RECORD SET OF DRAWINGS
This set of drawings is provided by the Contractor as a schematic of the project in place. The Architect has not verified these conditions and is not responsible for conclusions drawn therefrom.
CHERRY/SEE ARCHITECTS 11/2/97 msc

TITLE: PHIL CHACON PARK PHASE I
SITE BOUNDARY SURVEY

Edith Cherry D. James See Architects <small>220 A. Road SW, Albuquerque, New Mexico, 87102 505.262.0211</small>	
CITY OF ALBUQUERQUE PARKS AND GENERAL SERVICES DESIGN & DEVELOPMENT DIVISION	
TITLE: AS BUILT CHANGES	
Design Review Committee	City Engineer Approval
City Project No. 4723.01	Zone Map No. L-18-Z
Sheet 26	Of 26

POWER RISER DIAGRAM
NO SCALE

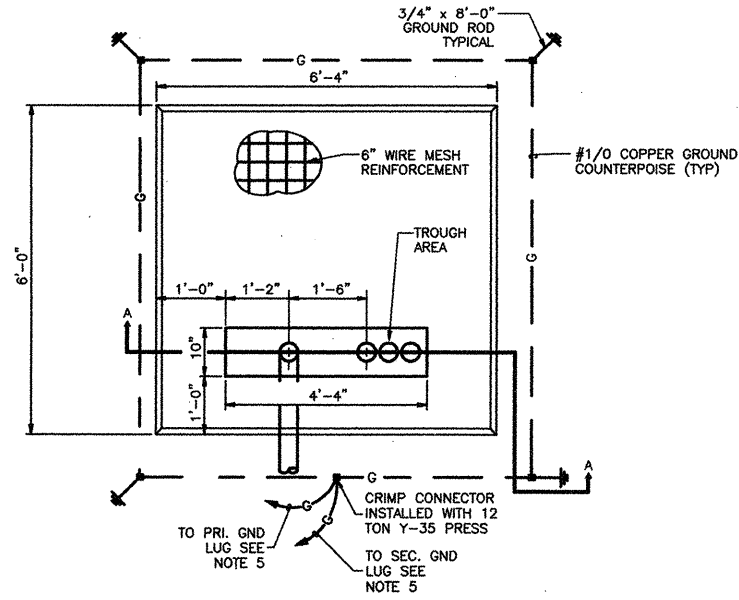
Power Riser Diagram, delete Keyed Note 1 & 2 from meter to pole. Add Keyed Note 17 on feeder from meter to pole.

Add Keyed Note 17 to read as follows:
"Contractor shall be responsible for 600 feet of 4" IMC conduit and trenching from the primary meter to a new PNM switch located at the north / east corner of the property. Coordinate exact location and trench requirements with PNM. Coordinate routing of conduit with the Owner prior to trenching, this route will become PNM's easement."

EXHIBIT B ADDENDUM #1

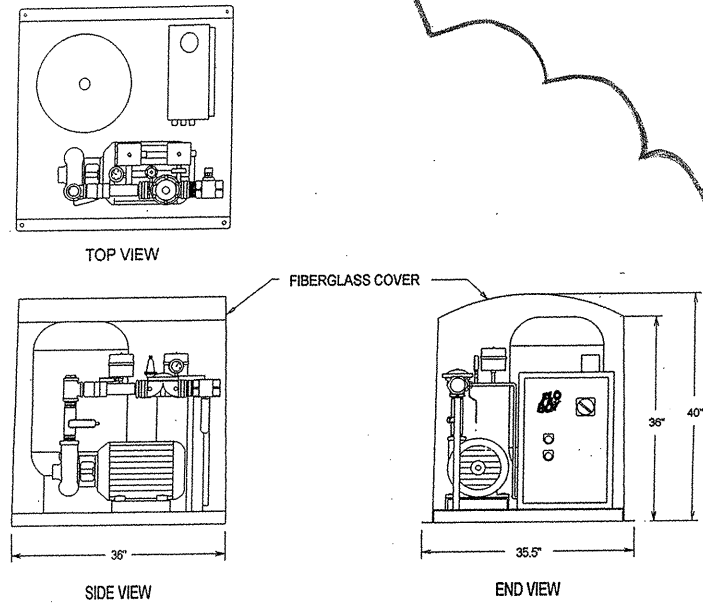
Sheet L-6 Irrigation Legend **P** - Stand alone booster pump FloBoy Model #FBS-1-PR-S refers to attachments Exhibit A and B of this addendum.

ASI #1-A

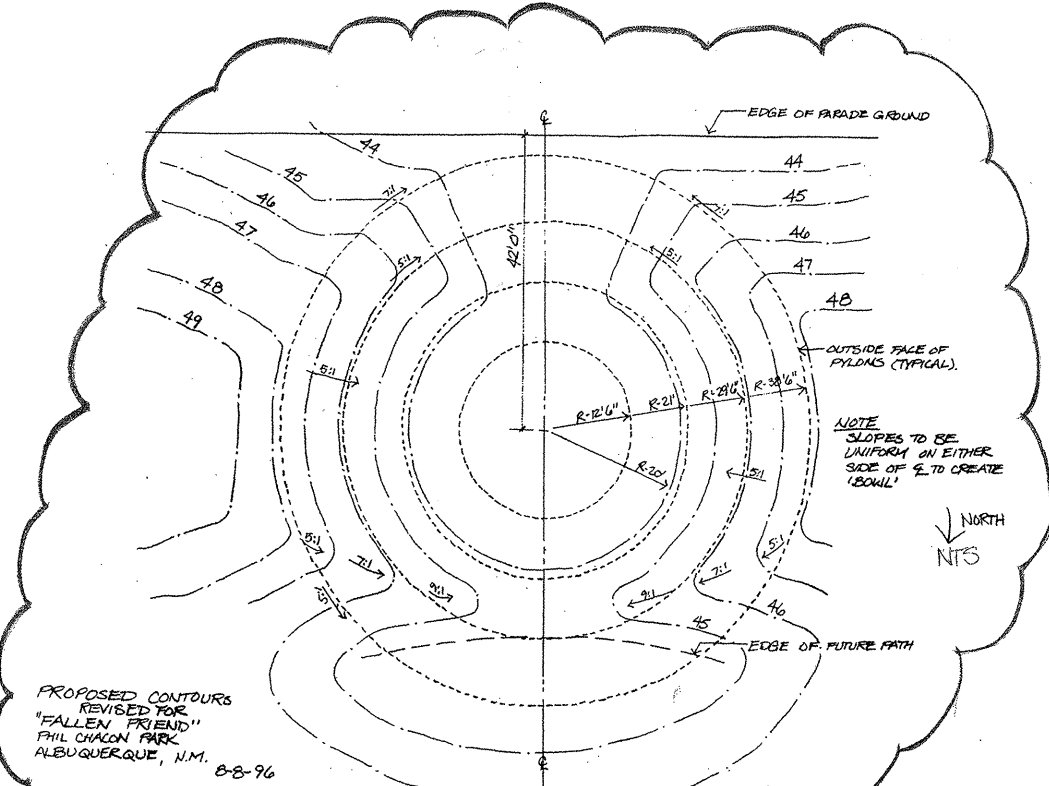
1. Provide a cost proposal for the installation of additional concrete work, see attached Exhibit A for more information. The situation shown in Exhibit A refers to two locations, one on either side of the amphitheater.
2. Add steel edging as shown in Exhibit A.
